Item H-4

Consider a resolution approving a Site Plan with variances for a new proposed restaurant building, on approximately 0.69 acres, located at the southeast corner of the Keller Parkway and South Elm Street intersection, legally described as Lot 2R, Block A of the Elm Keller Parkway Addition and addressed 200 South Keller Parkway. Rodney Martinez/Tommy Zheng, Applicants. SCI Texas Funeral Services, Inc., Owner. (SITE-2503-0003)

Site Layout: Variances Requested:

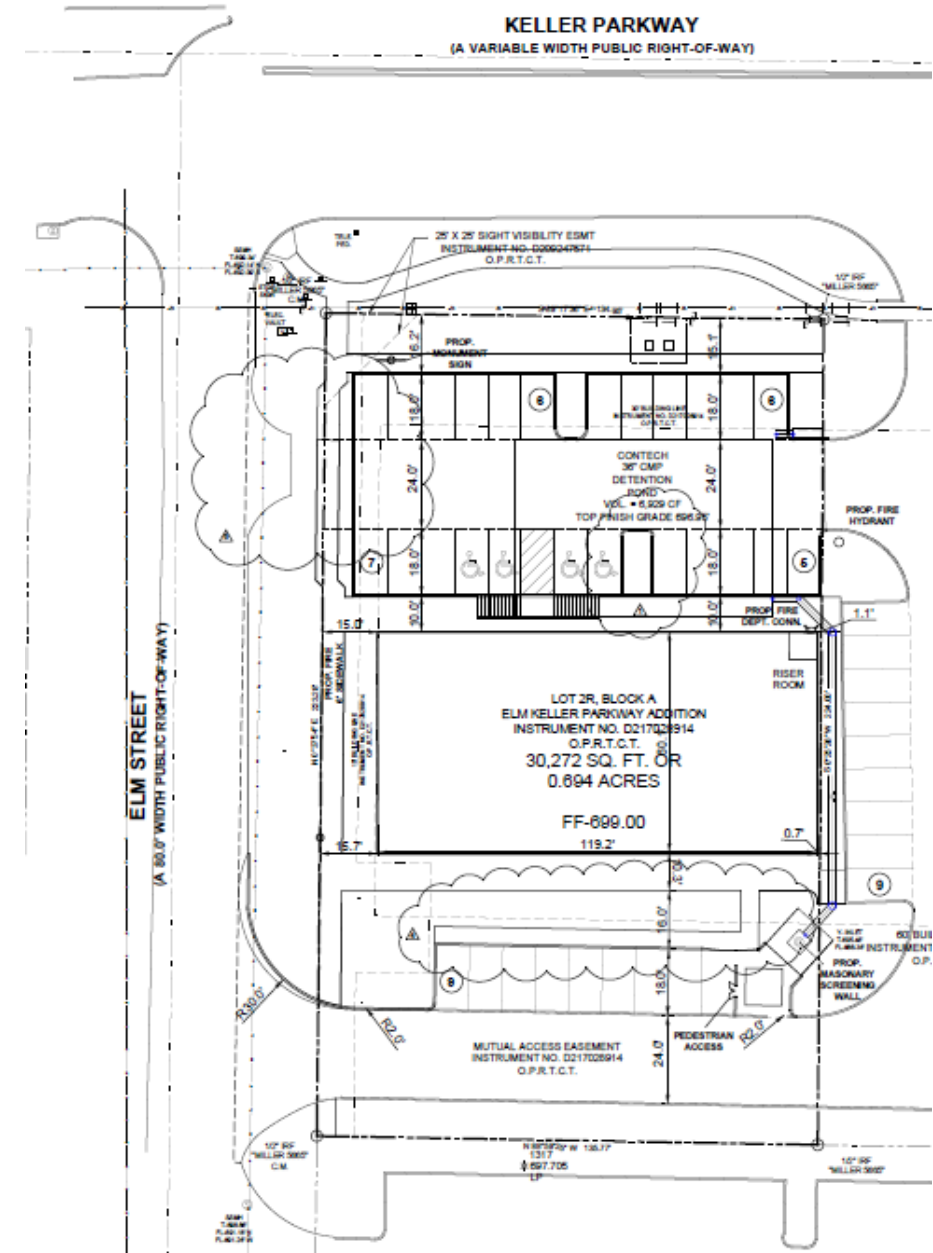
Unified Development Code (UDC) 8.19(5)(f) prohibits parking areas in front of buildings in the Main Street Subdistrict.

1. The Applicant requests a variance to allow parking in front of the restaurant building (between the building and Keller Parkway.

UDC Section 9.02 defines the parking ratio for full-service restaurants as one space per 150 square feet of gross floor area, bringing the total parking requirement to 48 regular spaces, plus accessible spaces.

-
2. The Applicant requests a variance to under park the site by 19 spaces.

Landscaping/Buffers: Variance Requested

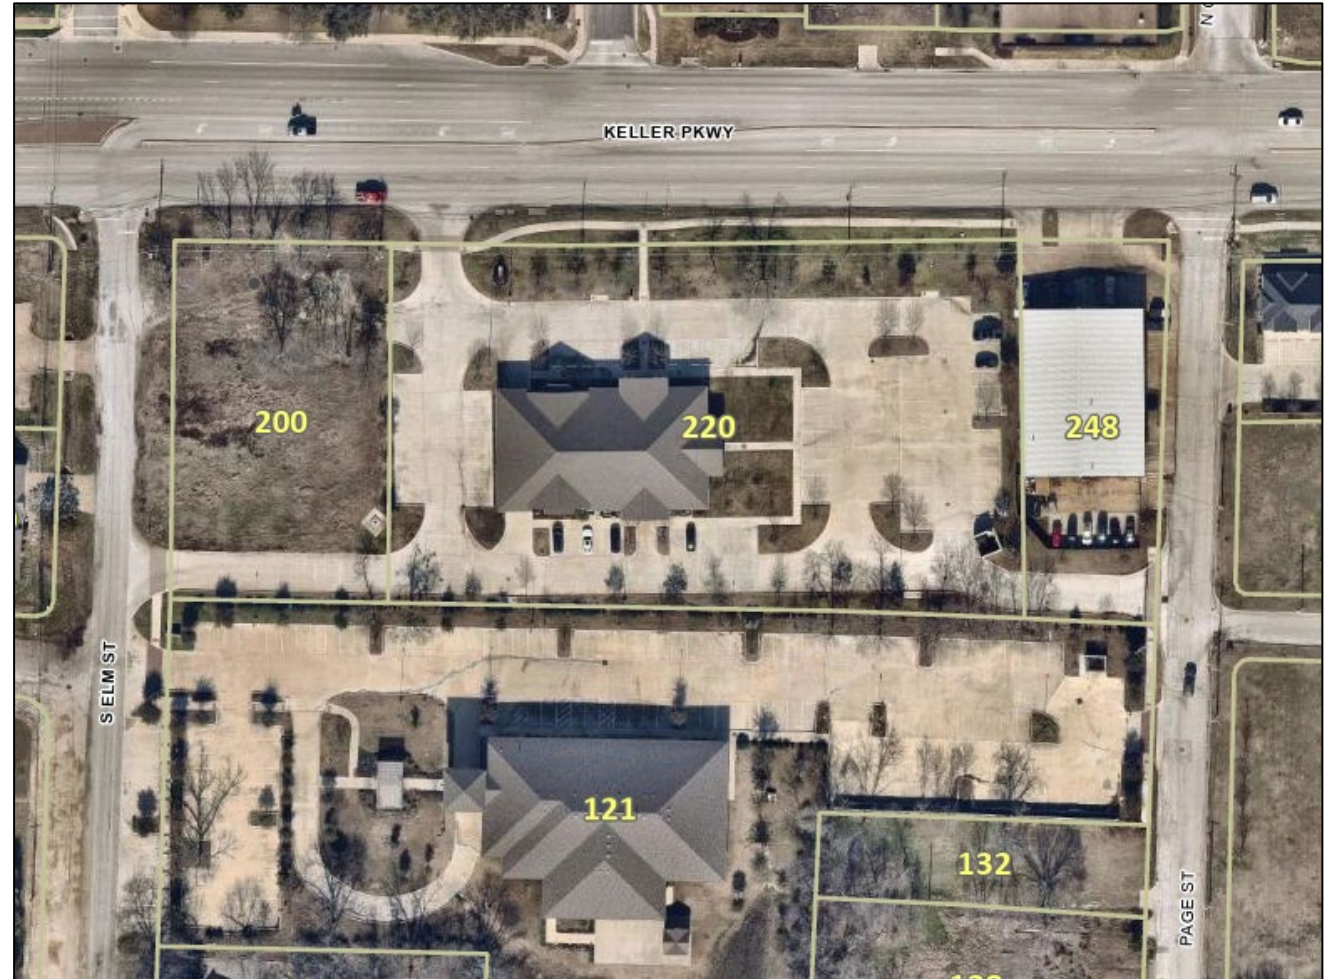
UDC Section 9.03(F)(1) requires a minimum thirty-foot (30') landscape buffer adjacent to all thoroughfares with four (4) or more lanes as classified on the current Comprehensive Thoroughfare Plan, which includes Keller Parkway.

3. The Applicant requests a variance to install an approximately 15' wide landscape buffer along the north property line in lieu of the 30' requirement.

UDC Section 9.03(F)(b) requires a minimum fifteen-foot (15') landscape buffer adjacent to all other public streets.

4. The Applicant requests a variance to provide no landscape buffer along the west property line (adjacent to South Elm Street).

At the May 27, 2025, Planning and Zoning Commission meeting, Commissioners unanimously recommended approval of the Site Plan with four variances, with the condition that the landscape buffer along the northern property line be a minimum of 15' in width.
